# Access Compliance Report

## Public Rights-of-Way

Intersection ID: 10041631	Main Street: WHITEHALL_PARK_DR	Cross Street: N/A	Location: E
ADA ID: D1F55077CE2C	Ramp Type: PerpDiag	Initial Pass/Fail: Fail	Overall Compliance: No
Severity Score: 22.5			
Codes/Mitigation Info/Possible Solution		Field Measurements/Component Compliance

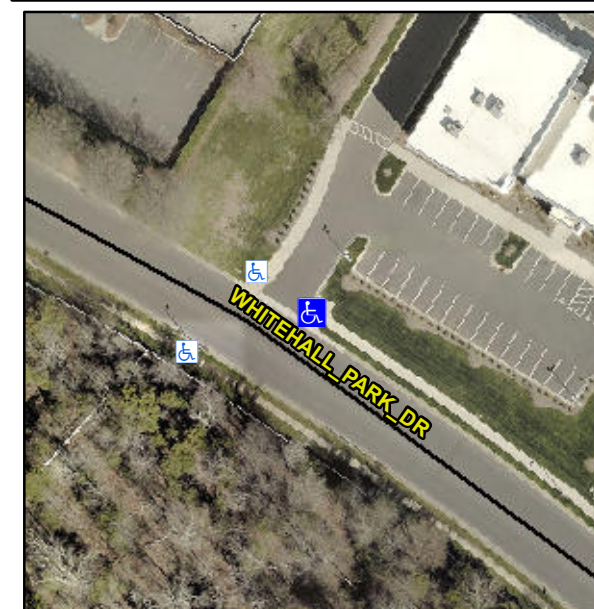
**R304.5.1, R304.2.2, R304.5.3**

Compliance	Description	Data	Compliance	Description	Data
N/A	Ramp Length (in)	60.0	No	Ramp Slope (%)	8.6
No	Ramp Width (in)	46.0	No	Ramp XSlope (%)	3.2
N/A	Flare Type LT	N/A	N/A	Flare Type RT	N/A
N/A	Flare Slope LT (%)	N/A	N/A	Flare Slope RT (%)	N/A
N/A	Flare Traversable LT?	N/A	N/A	Flare Traversable RT?	N/A
N/A	Landing Length (in)	N/A	N/A	DWS Provided?	N/A
N/A	Landing Width (in)	N/A	N/A	DWS Contrast?	N/A
N/A	Landing Slope (%)	N/A	N/A	DWS Length (in)	N/A
N/A	Landing X Slope (%)	N/A	N/A	DWS Full Width?	N/A
N/A	Landing Curb? (Y/N)	N/A	N/A	DWS Offset (in)	N/A
N/A	Shared Landing?	N/A			
N/A	Gutter Ponding?	N/A	N/A	Gutter Slope (%)	N/A
N/A	Gutter Lip Ht (in)	N/A	N/A	Gutter X Slope (%)	N/A
N/A	Painted X Walk1?	No	N/A	Painted X Walk2?	No
	X Walk 1 Direction	To NW		X Walk 2 Direction	To SW
N/A	X Walk 1 Width (in)	N/A	N/A	X Walk 2 Width (in)	N/A
	X Walk 1 Slope (%)	1.5		X Walk 2 Slope (%)	1.8
	X Walk 1 X Slope (%)	3.5		X Walk 2 X Slope (%)	0.7

**Remove & Replace Curb Ramp With Two New Directional Ramps or Equivalent.**
